MP ref: M2418-RAL-1 DA ref: AP2025/004 QA: aa.ms.af

Re: Response to Information Request

Development Application seeking a Development Permit for Reconfiguring a Lot – Subdivision (One Lot into Three Lots) on land described as Lot 1 on SP273456 and located at 37839 Bruce Highway, Stuart

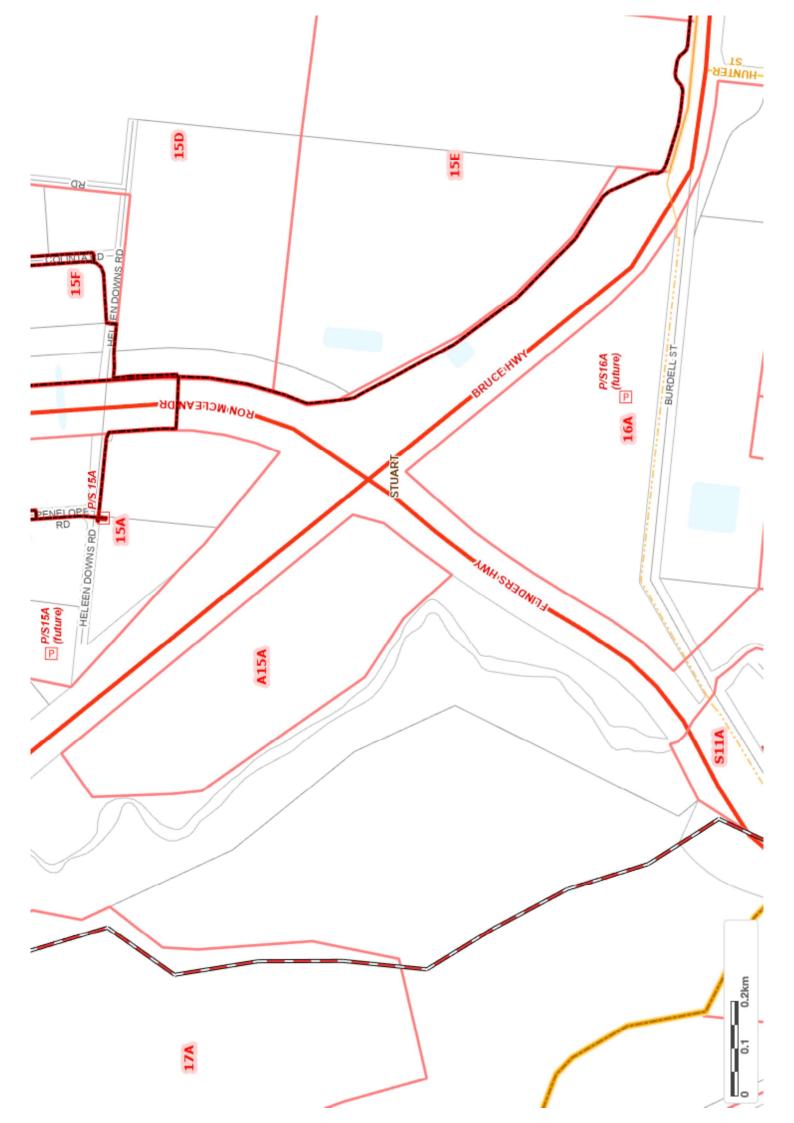
The proponent is required to provide the Coordinator-General with a response to the information requested below. The requested additional information seeks to clarify inadequacies in the application material provided, including the potential for servicing of the proposed lots.

In response to this item, it is confirmed that each of the proposed allotments achieve road frontage, which will be retained as a result of the subdivision that seeks to formalise the existing arrangement. The road frontages afforded to each of the allotments either accommodate or are intended to accommodate all relevant infrastructure. Further detail regarding each of the services in provided below.

The locality is serviced by Council's reticulated water network, with trunk water infrastructure located in the Ron Mclean Drive and Flinders Highway frontages of the subject allotments. The location of Council's reticulated water network, including the trunk main identified above, can be seen in **Attachment 2**.

The locality is also serviced by Council's reticulated sewer network, with the land identified as being within the sewer catchment area to be serviced by future sewer infrastructure. The location of Council's reticulated sewer network and the relevant catchment areas can be seen in **Attachment 3**.

The subject allotments are adjacent the existing electricity distribution network, which is located both within the adjoining road reserve and within the subject land. A map of the existing electricity infrastructure, which will ultimately be used to service the proposed allotments, is provided at **Attachment 4**.

The subject land is also within the National Broadband Network's (NBN) telecommunications network service area. In particular, the land will be serviced by the fixed line NBN network, as confirmed by the plan provided at **Attachment 5**.

Given the above, given the infrastructure networks available as outlined above, it is clear that the proposed lots can be serviced by water, wastewater infrastructure, electricity and telecommunications at the time of future development on the land.

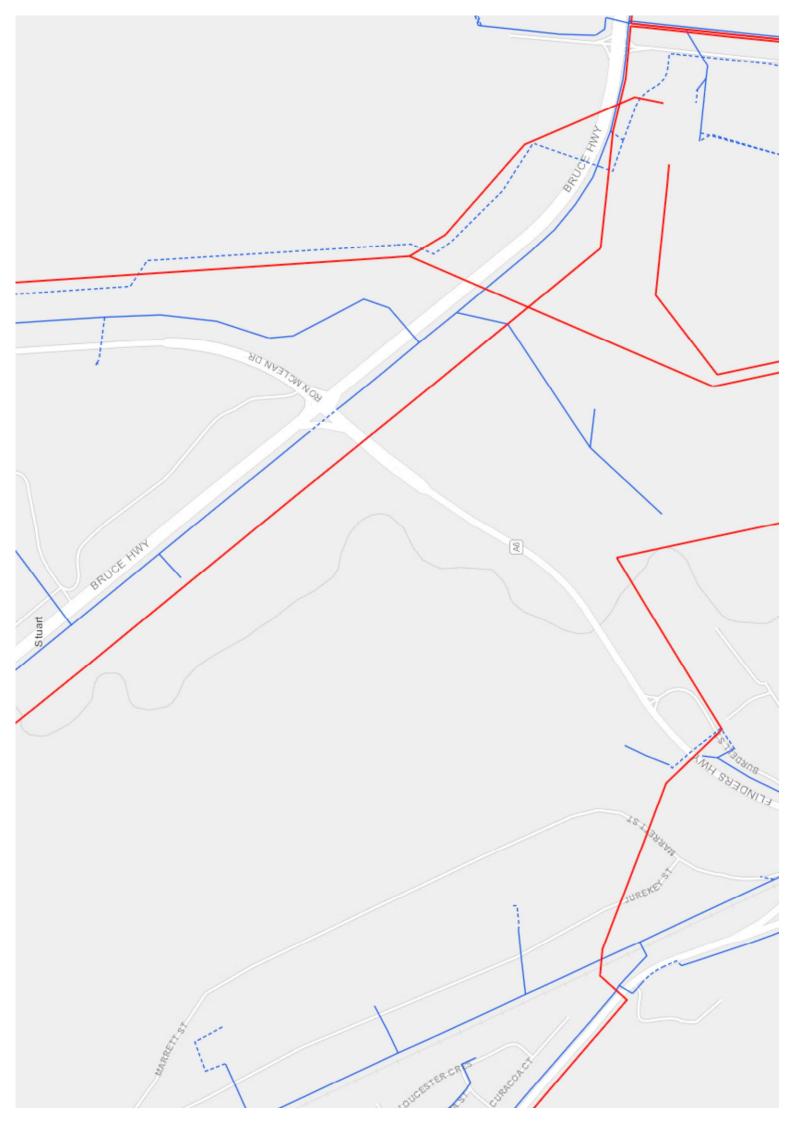
Envir	Environmental Management Precinct (EMP)	ent Precinct (EMP)
7	Subdivision within the EMP	The Development Application (Ref M2418-RAL-1), prepared by Milford Planning in May 2025, states that the proposed development is compliant with section 2.5.13 – 'reconfiguring a lot' - of the Townsville SDA Development Scheme. However, further clarification is required to demonstrate consistency with section 2.5.13(4), relating to further subdivision of the Environmental Management Precinct.
		As stated in criteria 2.5.13(4), "Further subdivision of the Environmental Management Precinct is not supported, unless being undertaken for operational, management or regulatory purposes, or if there is an overriding need."
		The proponent is requested to provide an updated response to section 2.5.13 of the Townsville SDA Development Scheme (dated May 2019). The response must provide further details to justify the proposed subdivision of land within the Environmental Management Precinct and a response that considers the proposal's consistency with section 2.5.13(4).

In response to this item, as explained in the development application package, the subdivision is administrative in nature and will not result in any physical changes to the land. The proposed further subdivision of land in the Environmental Management Precinct will be undertaken to manage the existing fragmented land parcel, and will facilitate the efficient future operation of the land for end users. As such, the development aligns with the requirements and intent of Section 2.5.13 (4) of the development scheme.
